# Technical Service Information

## CHRYSLER A500/518

### L/R DRUM THRUST WASHER ELIMINATED

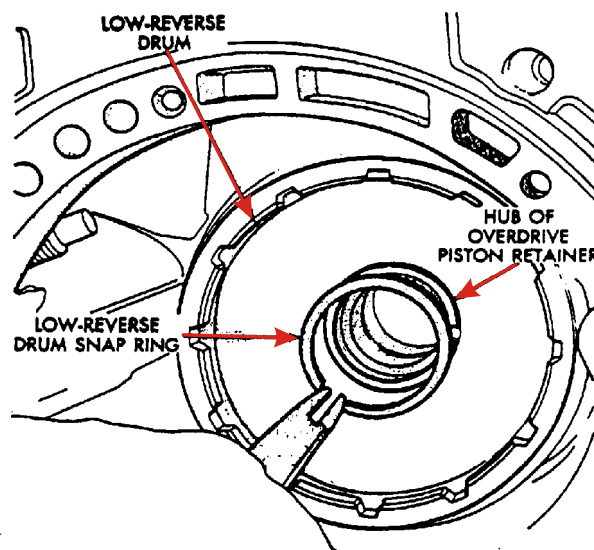
**CHANGE:** During the 1989 model year, a running change was made to the Low/Reverse drum, that eliminated the thrust washer under the snap ring that holds the Low/Reverse drum on the overdrive piston retainer (See Figure 1).

(1) LOW/REVERSE DRUM ASSEMBLY - The thrust washer recess in the center of the Low/Reverse Drum was eliminated, as shown in Figure 2.

(1) 1ST DESIGN LEVEL - The Low/Reverse Drum WITH the thrust washer recess in the center of the drum REQUIRES the thrust washer between the snap ring and the Low/Reverse Drum (See Figure 2).

(2) 2ND DESIGN LEVEL - The Low/Reverse Drum WITHOUT the thrust washer recess (Flat Surface) in the center of the drum does not use the thrust washer. (See Figure 2).
